# National TAB

Project: 02-23-26 WHATABURGER #1644 GARNER, NC

Project Issue Information

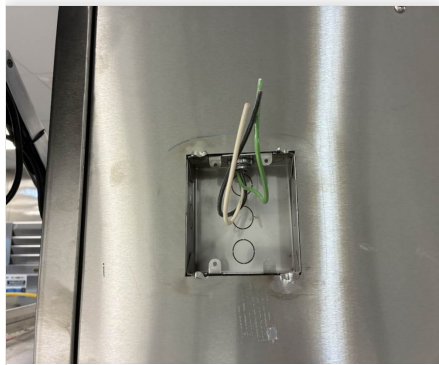
**Issue Name :** HD-1 Not Wired/Connected  
**Description :** The on/off switch for HD-1 is not wired. The technician from Chisholm Service says the hoods are also not connected to the RTUs. The switch needs to be wired and the hood systems connected to the RTUs.

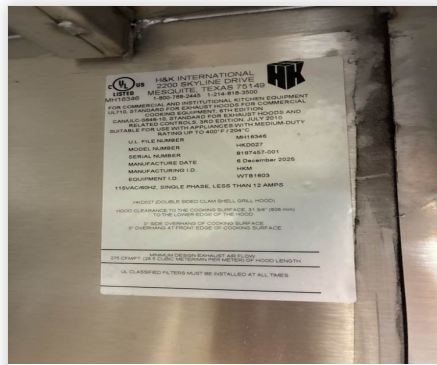
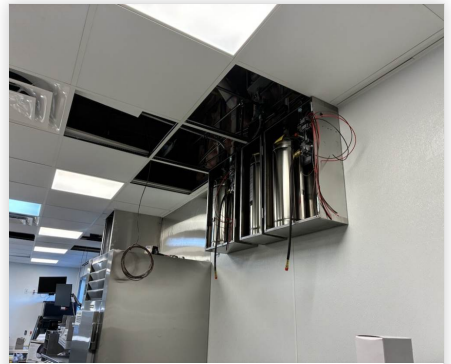
**Issue Name :** HD-2 Not Wired/Connected  
**Description :** The on/off switch for HD-2 is not wired. The technician from Chisholm Service says the hoods are also not connected to the RTUs. The switch needs to be wired and the hood systems connected to the RTUs.  
**Created By :** National TAB                      **Assigned To :** National TAB - Brianna Biggs  
**Status :** Open  
**Priority :** Urgent                                      **Asset Tag :** HD2  
**Originated Date :** 02/23/2026 - Alex Bauer - National TAB

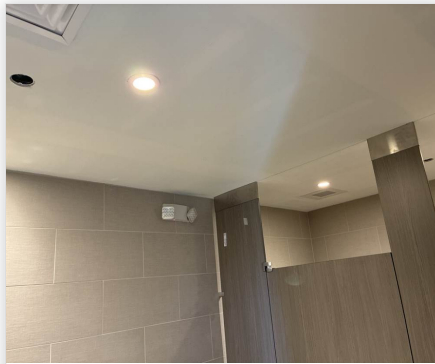
**Issue Name :** Motion Sensors Not Installed in Restrooms  
**Description :** The motion sensors to activate the EF-1 fan damper and to turn on EF-1 are not present. Without these sensors the fan cannot turn on. It would be best to install the sensors so the fan can function.  
**Created By :** National TAB                      **Assigned To :** National TAB - Brianna Biggs  
**Status :** Open  
**Priority :** **Urgent**                                      **Asset Tag :** EF1  
**Originated Date :** 02/23/2026 - Alex Bauer - National TAB
